COLAC OTWAY SHIRE COUNCIL PLANNING COMMITTEE MEETING

PA2403395-2-4 and 6 Miller Street, Colac - Submission and Planning Application to Minister of Planning

ADDRESS AND PROPERTY DETAILS	2-4 & 6 Miller Street, Colac (Crown Allotments 1, 2 & 3 Section 48)	APPLICATION NUMBER	PA2403395
PROPOSAL	Use and Development of the Land for Group Accommodation		
PERMIT TRIGGERS	Clause 32.08-2 – General Residential Zone (GRZ1) - Use of the land for accommodation (group accommodation). Clause 32.08-10 – General Residential Zone (GRZ1) - Construction of a building or construction or carrying out works for a use in Section 2 (permit required) of Clause 32.08- 2.		
TRIGGER FOR DETERMINATION BY COMMITTEE	Submission on Planning Application to Minister of Transport and Planning		
ZONE	General Residential Zone (GRZ1)	OVERLAYS	Nil
COVENANTS	Crown Grant only, relating to mining rights. The proposal would not result in a breach of the covenant.		
CULTURAL HERITAGE	N/A		
OFFICER	Bernadette McGovan	GENERAL MANAGER	Ian Seuren
DIVISION	Community and Economy		
ATTACHMENTS	1. Plans [7.1.1 - 14 pages]

DRAWING TITLE
SITE PLAN - PROPOSED

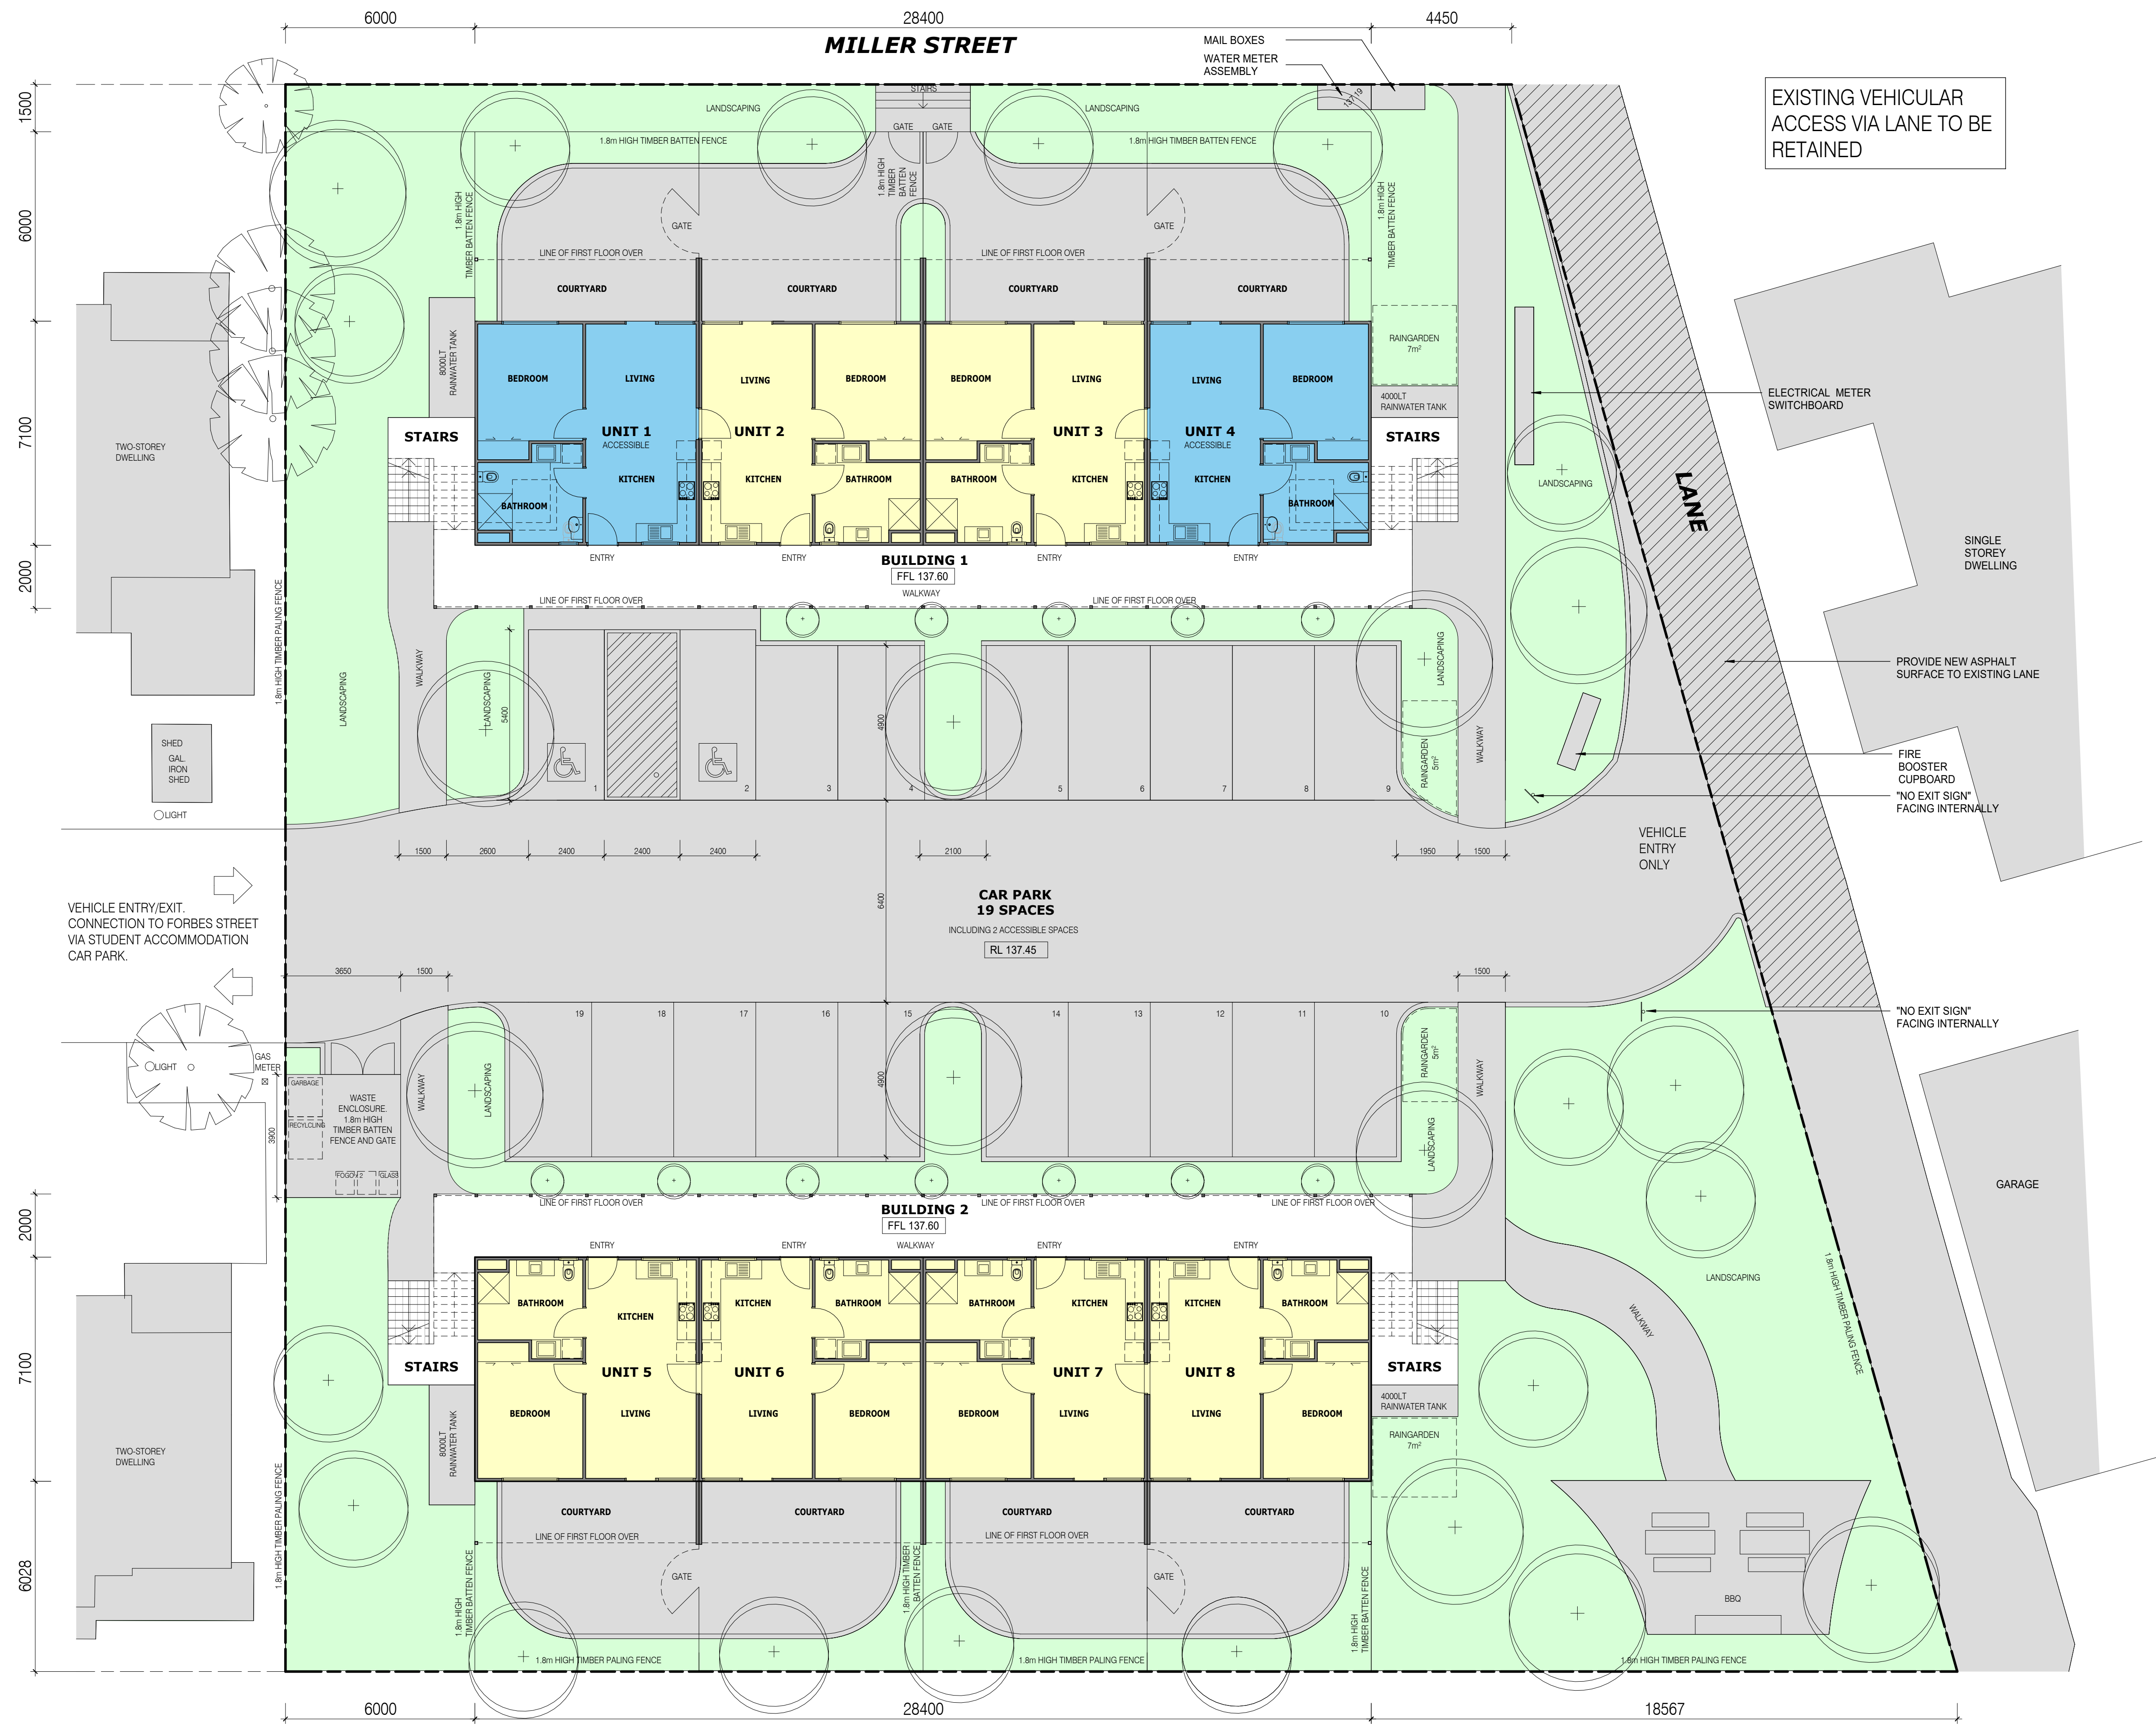
- *Safety and surveillance need improvement with lower, more permeable front fencing, the high impermeable front fence is not supported. Also, each ground level unit in Building 1 should have direct pedestrian access (a gate), providing a visible and easily identifiable entry from Miller Street without traversing a neighbouring courtyard.*

- *Consideration should be given to reduced paving to courtyards for increased garden/permeable area and reduced hard surface area.*
- *Consideration should be given to providing additional trees in the car parking area to provide shade and shelter, and to soften the appearance of the car park.*
- *Plant selections should have regard to the Indigenous Species List for Colac.*
- *Lighting of car parks and internal accessways should be shown.*

- *The access from Forbes Street may require widening (a 7.2m wide crossover); however, it is acknowledged that the swept paths in the Waste Management Plan show that trucks and cars would be able to enter and exit using the existing crossover.*

- *The proposed provision of on-site parking (19 spaces including 2 disabled spaces) is considered acceptable. Consideration should be given to allocation of parking to units.*

- the proposed 'entry only' access via the east abutting laneway is considered acceptable. Use of the laneway was originally not supported due to the impeded line of sight from on-street parking if exiting was permitted. On-site signage indicating 'No Exit' to the laneway would be required.

- sealing of the east abutting laneway to the southern site boundary is supported.
- the access from Forbes Street may require widening (a 7.2m wide crossover); however, the acceptable swept paths in the Waste Management Plan show that trucks and cars would be able to enter and exit using the existing crossover.

NORTH ELEVATION - BUILDING 1
SCALE 1 : 100

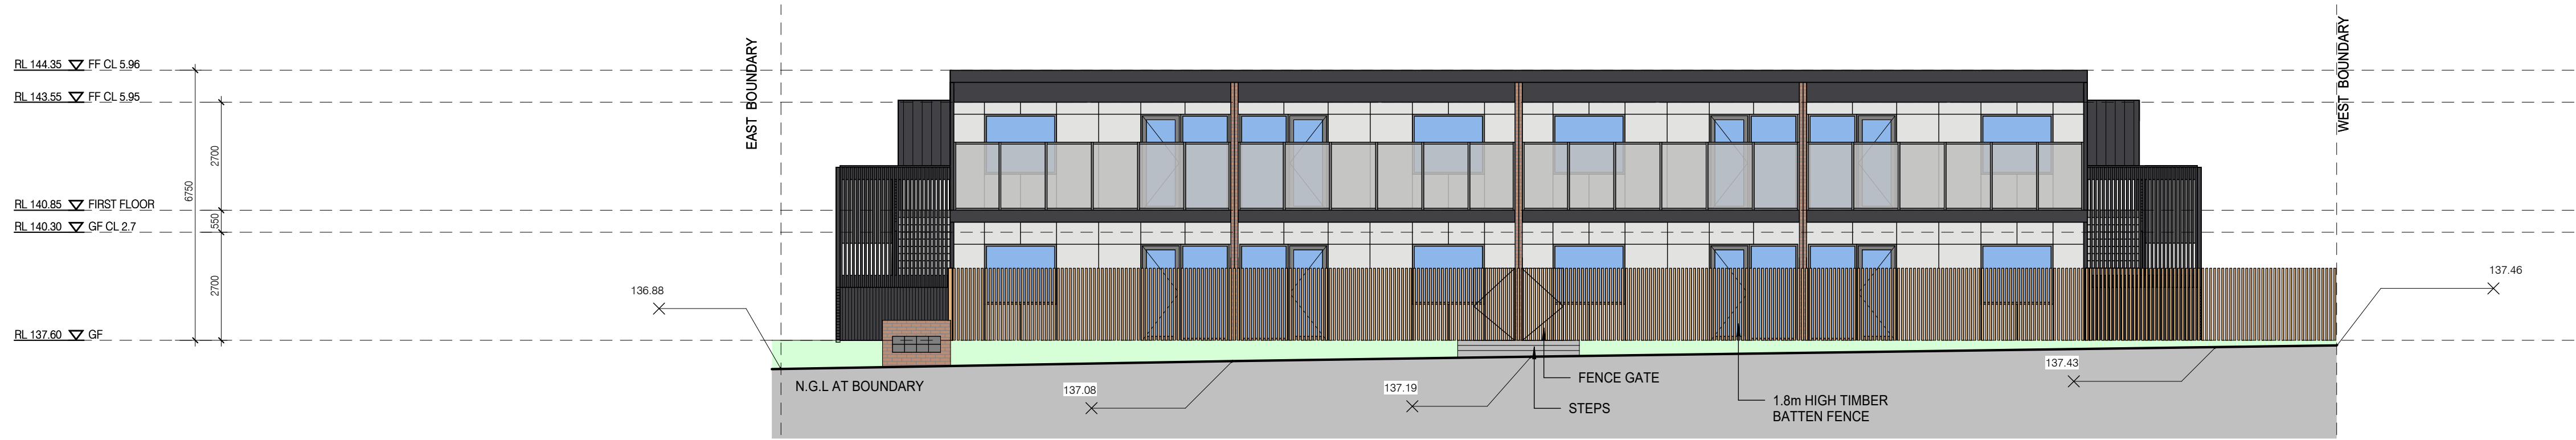
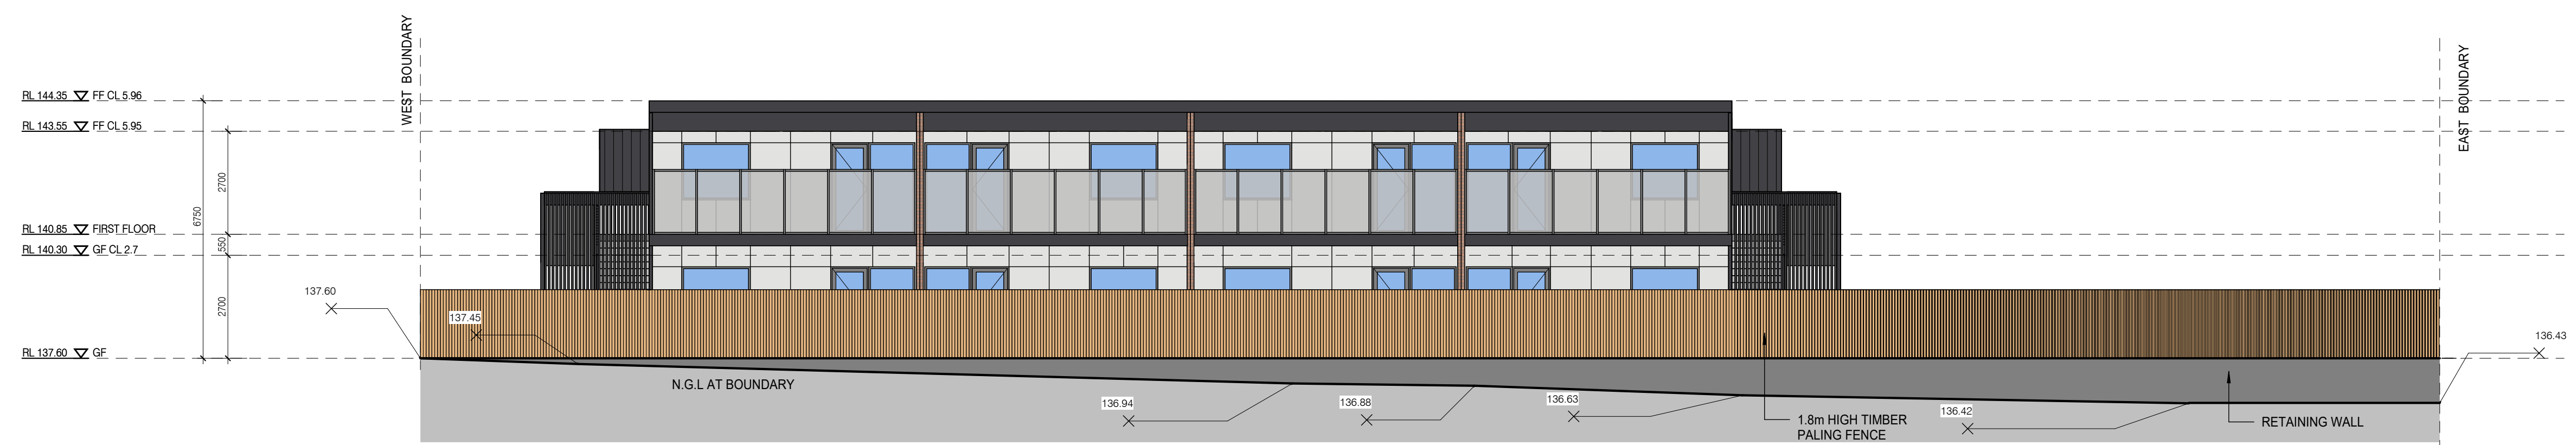
- *It is considered that the presentation of Building 1 to the Miller Street frontage could be improved with more activation, a greater mix of external colours and materials, and lower balustrades to first floor balconies. This would provide better surveillance and integration with the streetscape.*

- *Reduced height balustrades to first floor balconies could still satisfy Standard B23, which seeks to prevent internal overlooking of more than 50% of the secluded private open space (SPOS) of a lower-level dwelling (i.e. the SPOS area beneath each balcony would not be overlooked). Overlooking from first floor bedroom windows in the east and west elevations should also be addressed.*

The following observations are made with respect to specific Clause 55 provisions. It is considered that presentation to the Miller Street frontage could be improved with a greater mix of materials and lower balustrades to first floor balconies for better surveillance and integration with the streetscape. The safety and surveillance at the Miller Street frontage needs to be improved with a high front fence proposed adjacent the footpath, preventing view lines to and from the property. A lower, more permeable front fence, such as a 1.5-metre-high picket fence would be a better design response. In addition, it is considered that each ground level unit in Building 1 should have direct pedestrian access (a gate) providing a visible and easily

Screening is proposed to first floor balconies to prevent internal overlooking; however, as discussed above, reduced height balustrades could still satisfy Standard B23 which seeks to prevent overlooking of more than 50% of the secluded private open space (SPOS) of a lower-level dwelling (i.e. the SPOS area beneath each balcony would not be overlooked). Overlooking from first floor bedroom windows in the east and west elevations should also be addressed.
